CITY OF SEASIDE
BOARD OF ARCHITECTURAL REVIEW

B. ARCHITECTURAL REVIEW APPLICATION NO. BAR-15-14: COMMUNITY HOSPITAL PROPERTIES, PROPERTY OWNER, AND PAUL W. DAVIS, APPLICANT, ARE REQUESTING DESIGN REVIEW APPROVAL FOR THE CONSTRUCTION OF A NEW SINGLE-STORY MEDICAL/DENTAL/OFFICE/HEALTH CLINIC BUILDING AND ASSOCIATED SITE IMPROVEMENTS LOCATED AT 1150 FREMONT BOULEVARD IN THE COMMUNITY COMMERCIAL (CC) ZONING DISTRICT. THE PROJECT IS EXEMPT FROM THE CALIFORNIA ENVIRONMENTAL QUALITY ACT PURSUANT TO SECTION 15332, CLASS 32, IN-FILL DEVELOPMENT PROJECTS. (CONTINUED FROM THE SEPTEMBER 16, 2015 DESIGN BOARD OF ARCHITECTURAL REVIEW MEETING.)

Facility: 1150 Fremont Boulevard
Seaside, California 93955
Project Number: BAR-15-04
Project Title: Seaside Family Health Clinic
Response from BAR Continuance from 9-16-15 Meeting

A1.1-ALT

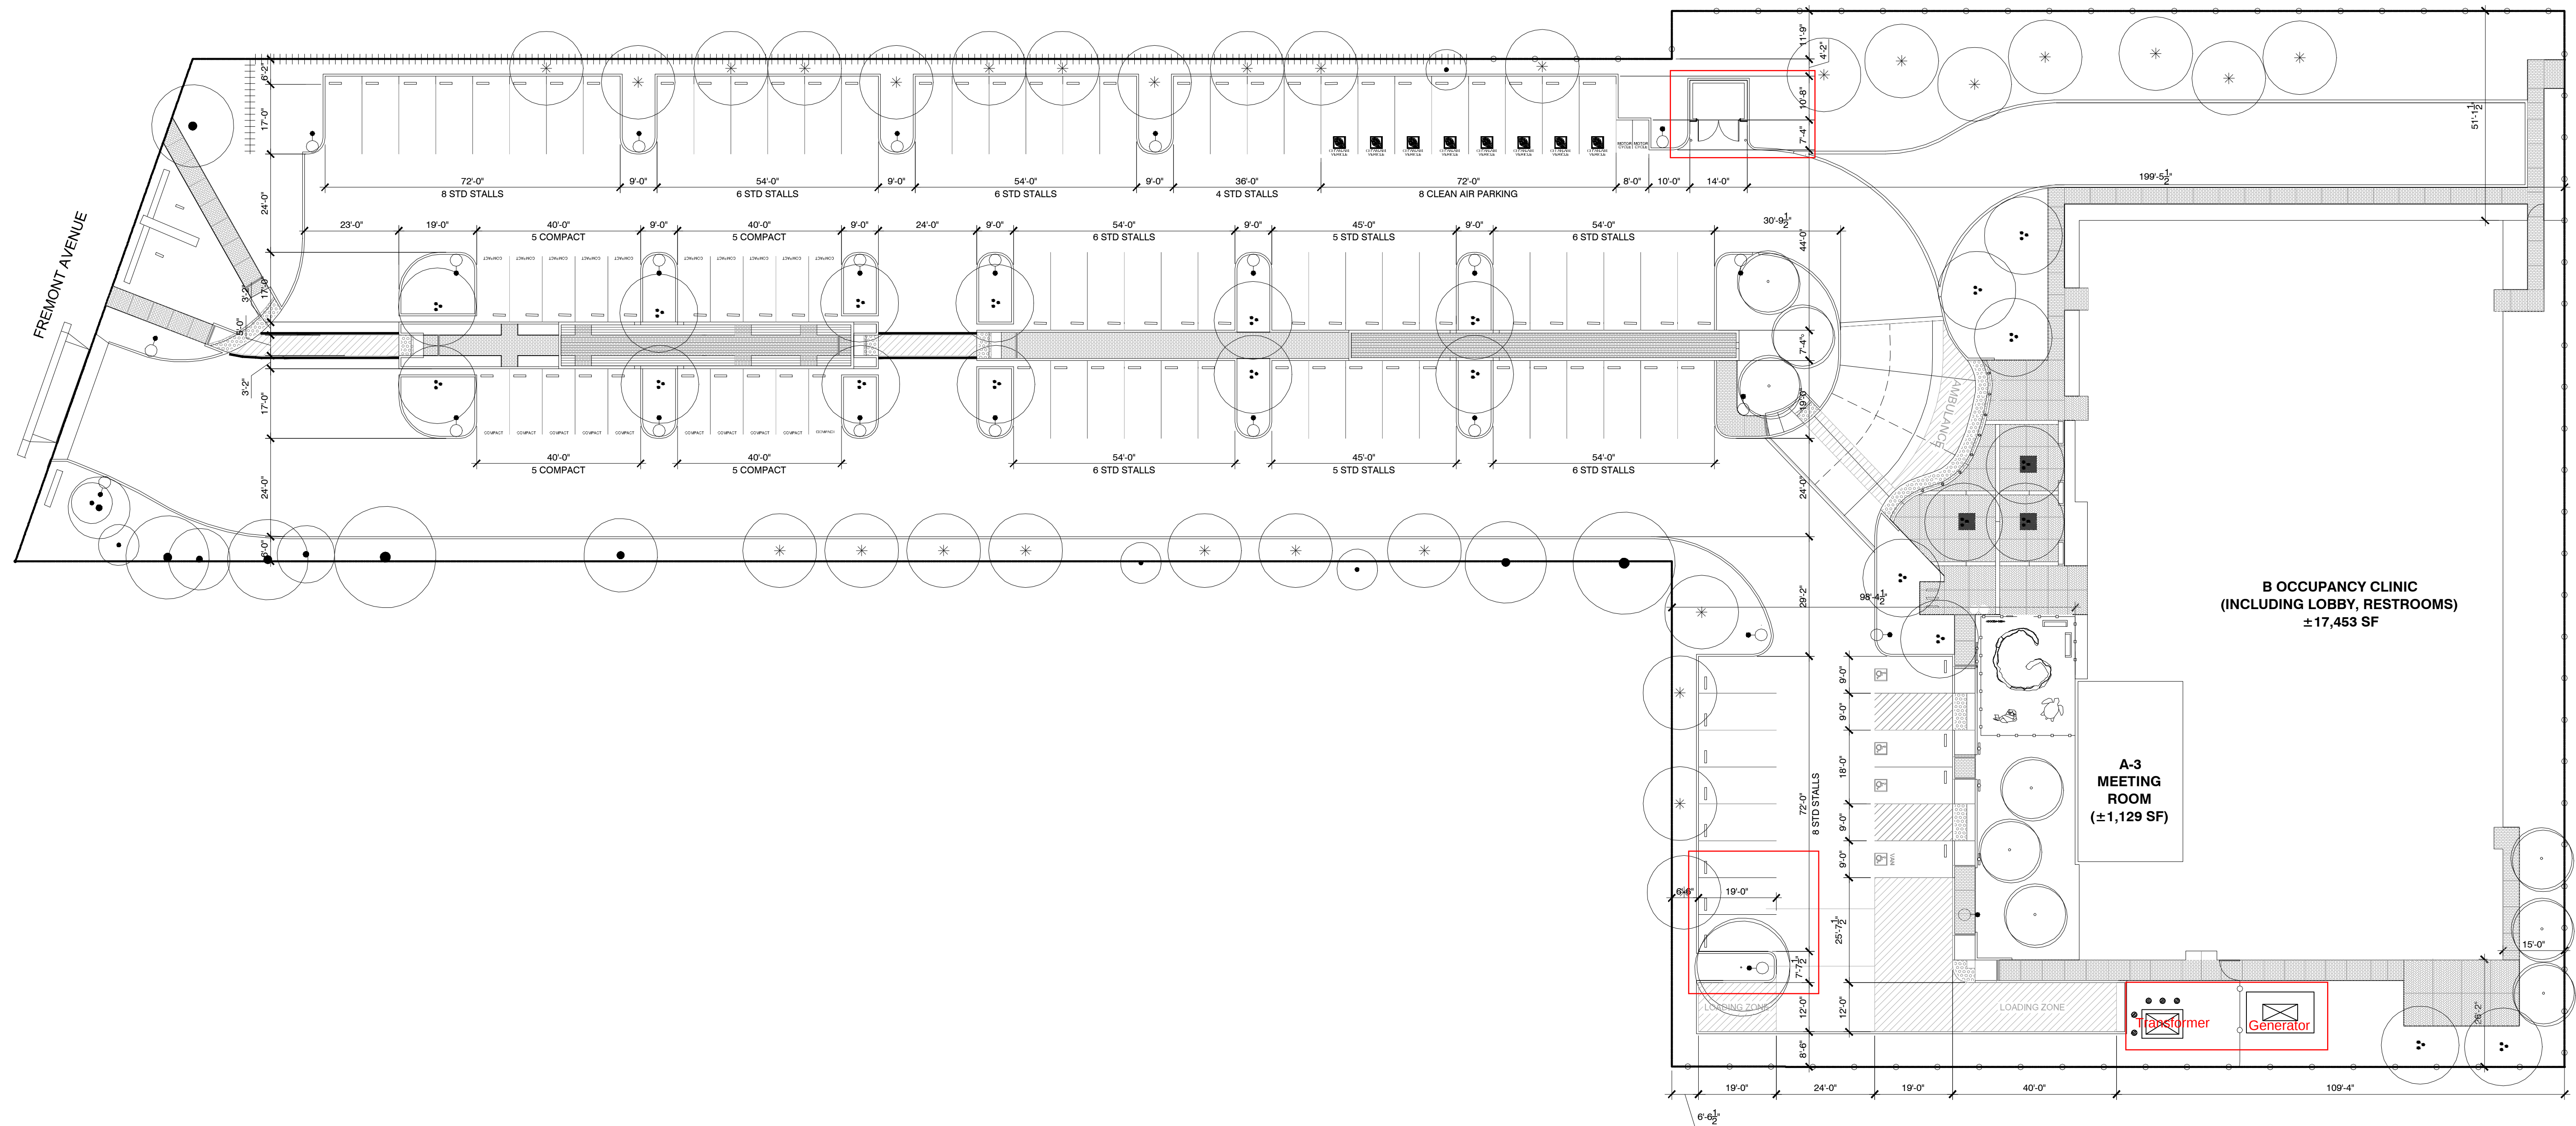
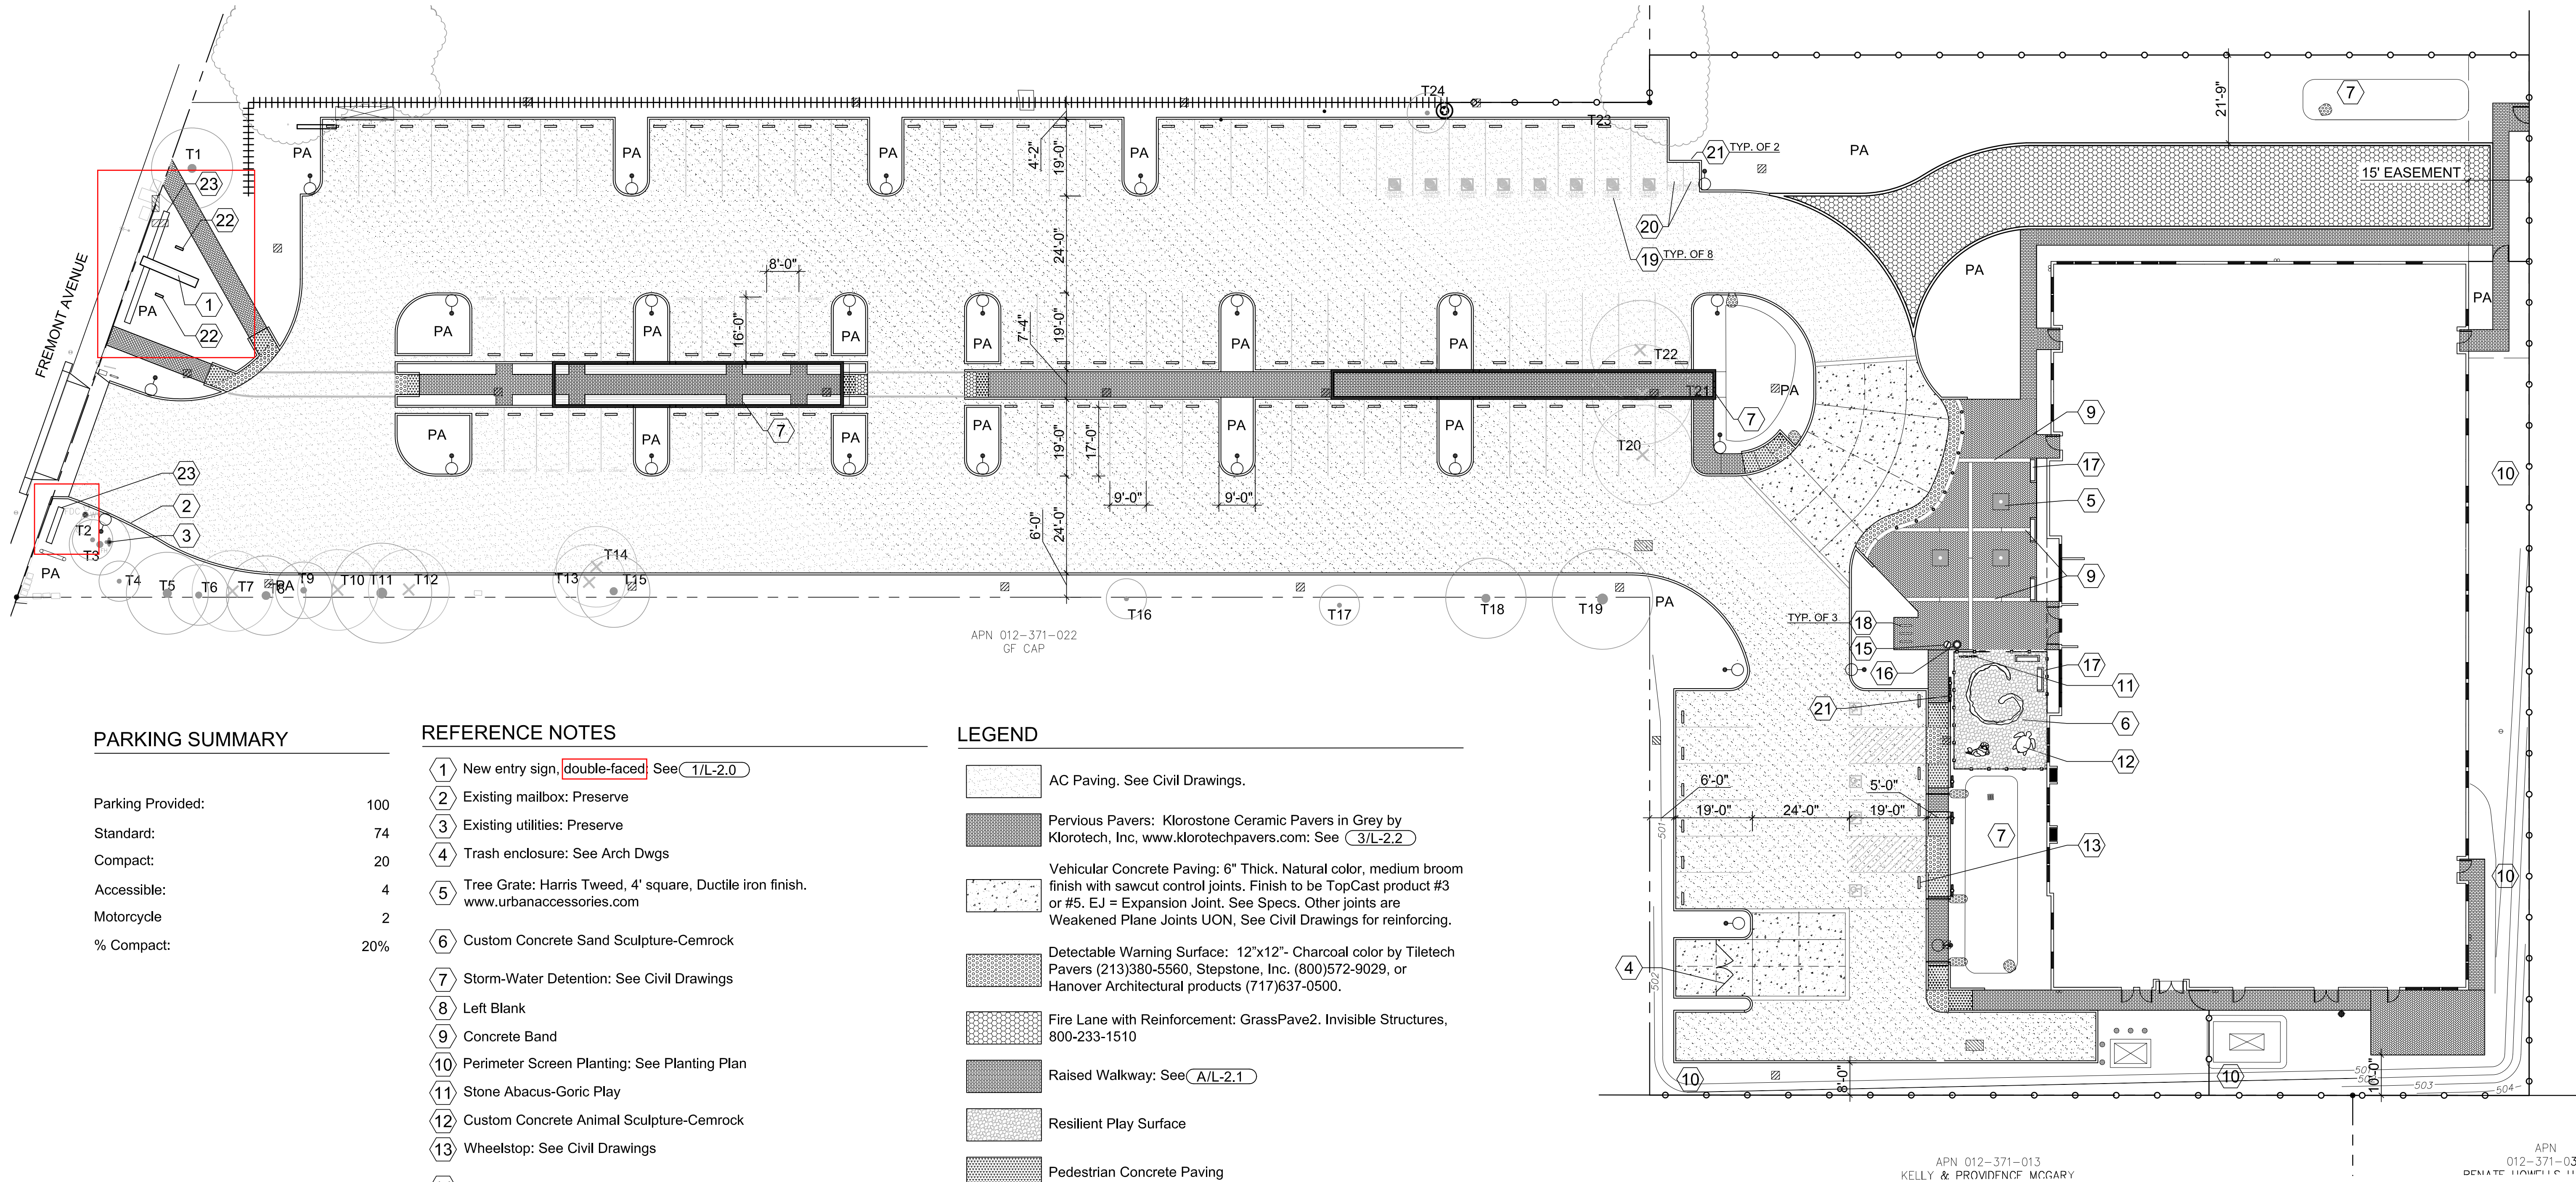
1. Landscaping – More specific plans were requested.
2. Trash/garbage – Consider relocating the trash enclosure to the north to minimize potential noise and odors that would of trucks and smell of garbage (neighbors to the south expressed concerns at the meeting).

Response: An alternate plan has been provided for BAR consideration. Should the alternate location be selected/ preferred, the landscape and stormwater designs will be updated accordingly. Please see sheet A1.1-ALT

Wood Fence - 4' Tall

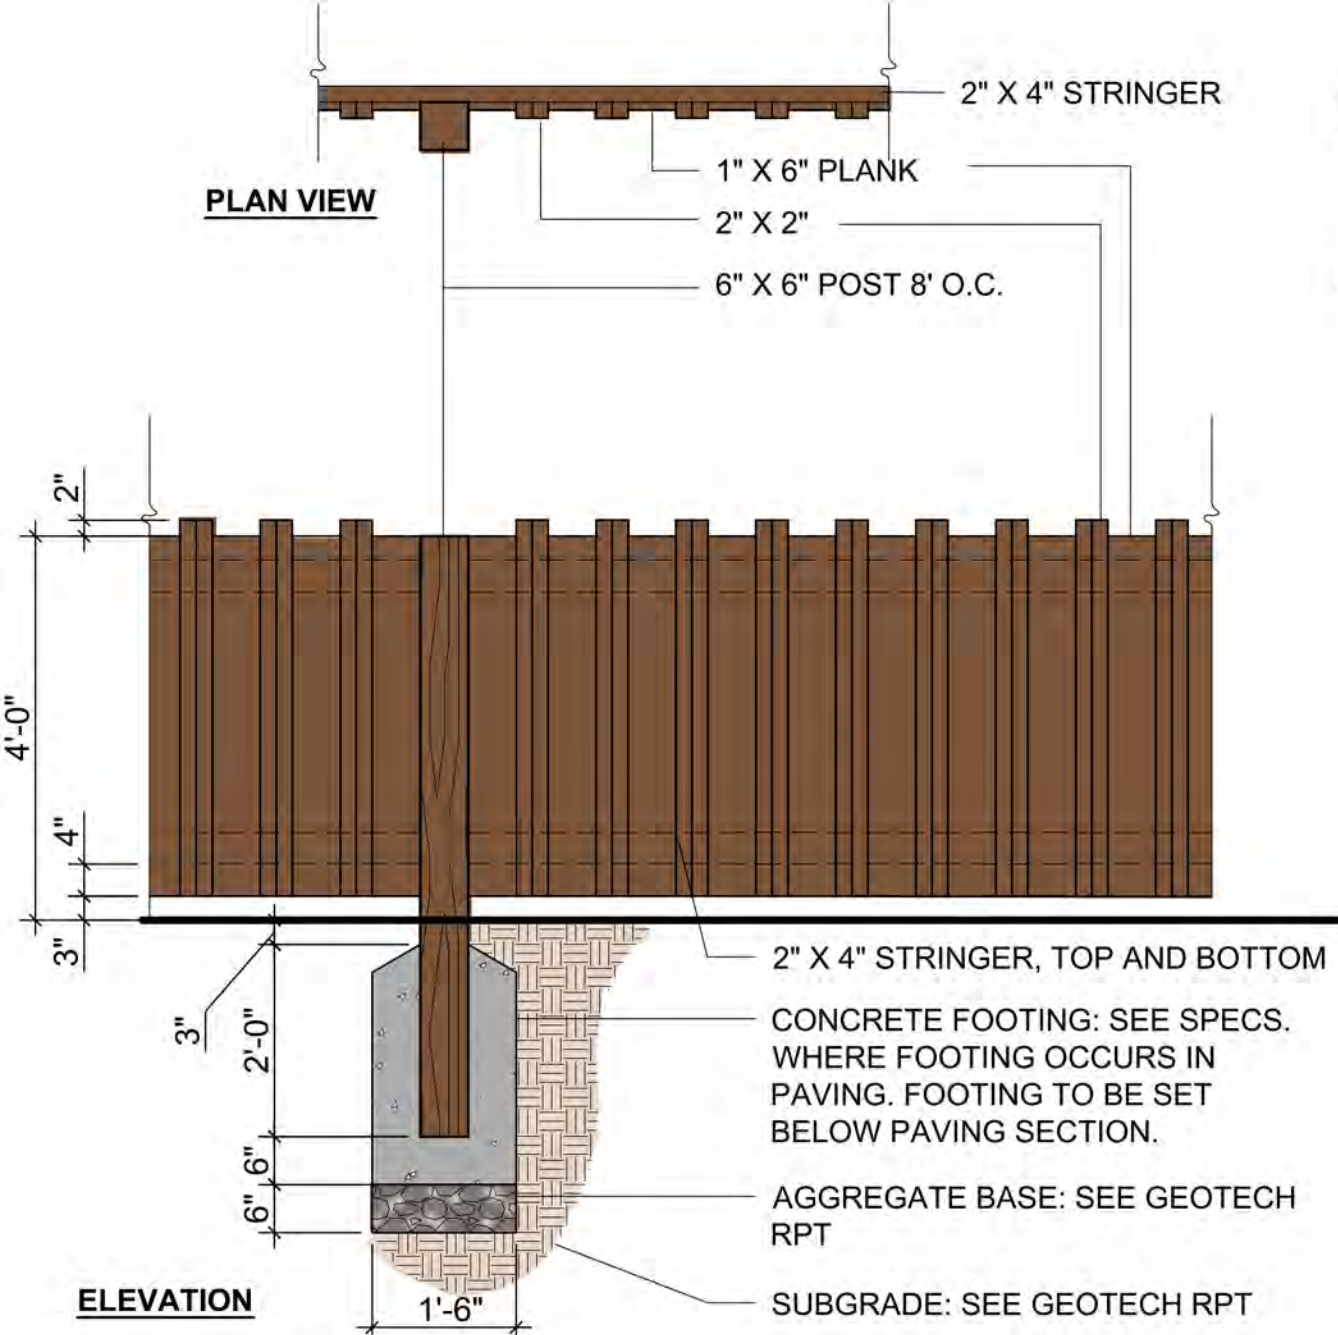
4. Lighting – Provide cut sheets for the individual light fixtures that will be used throughout the project.
5. Sign and fences – Provide updated fence and sign details on the color board.

5. Sign and fences – Provide updated details on the color board.
Response: The monument sign has not changed from the previous submission. The fence detail had previously been adjusted to reduce gaps between fence planks, and so a revised color fence elevation has been provided here.

2 GENERATOR MOUNTING DETAIL

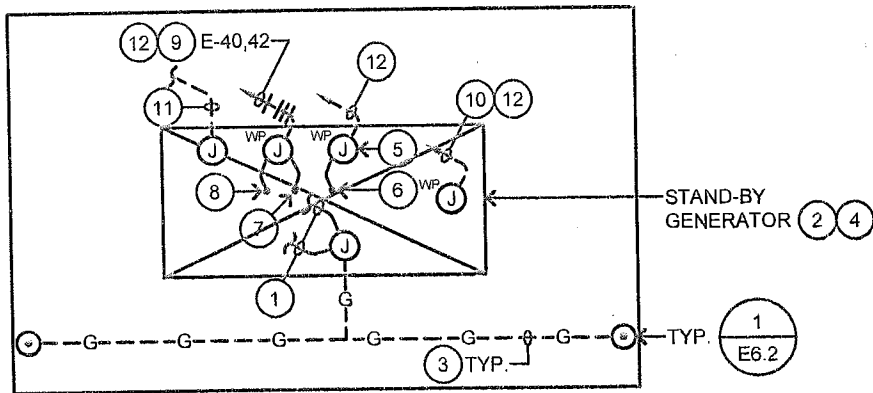
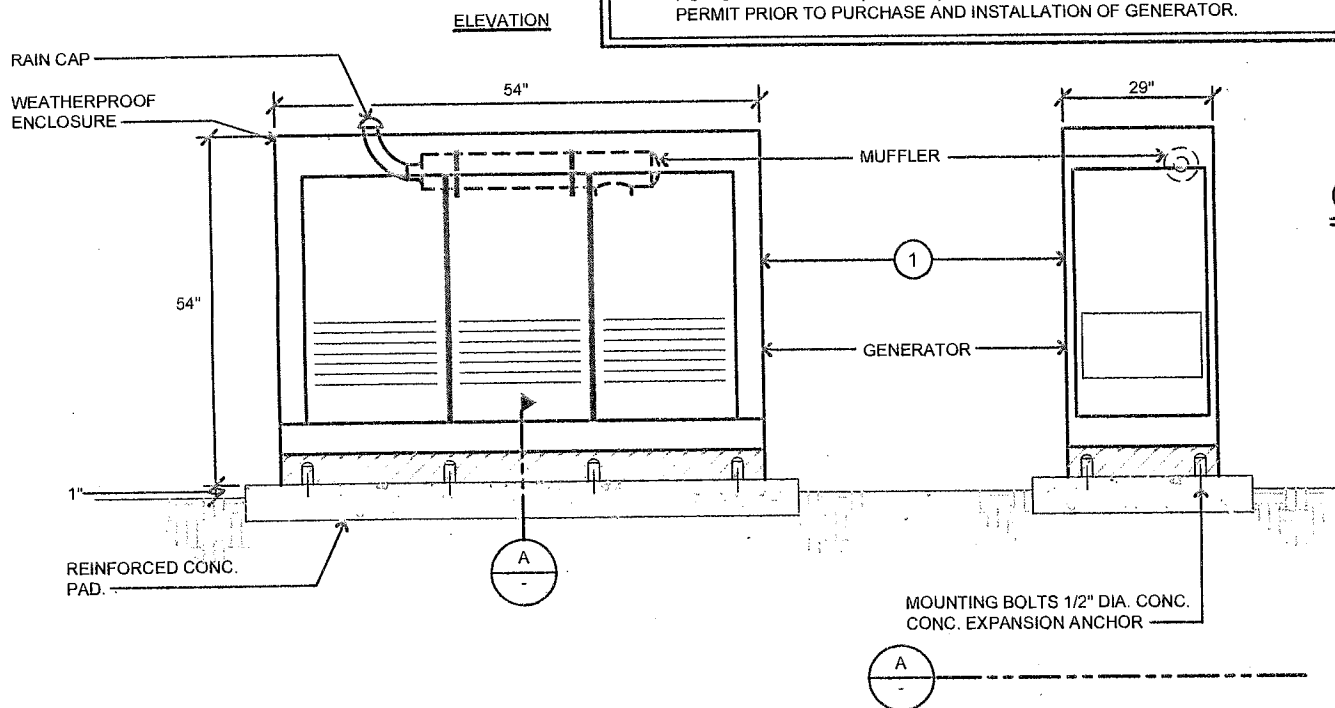
6. Generator – Provide information on location, noise levels, screening, and hours of operation.
7. Gate – Who controls the lock? What agreement is proposed for joint use with the City?

6. Generator – Provide information on location, noise levels, and hours of operation.
Response: Generator location is shown on sheet E2.1. Information on noise levels is provided here (single 11x17 size sheet). Exact hours of operation are undetermined as generator is planned for use when power fails. Regular maintenance/ inspection would occur once monthly for short periods of time (one hour or less, one day per month). Please note this generator is sized to support the critical functions of the building, which is maintaining climate conditions for vaccines and medications only; the generator is not sized to power a full operations of the facility.
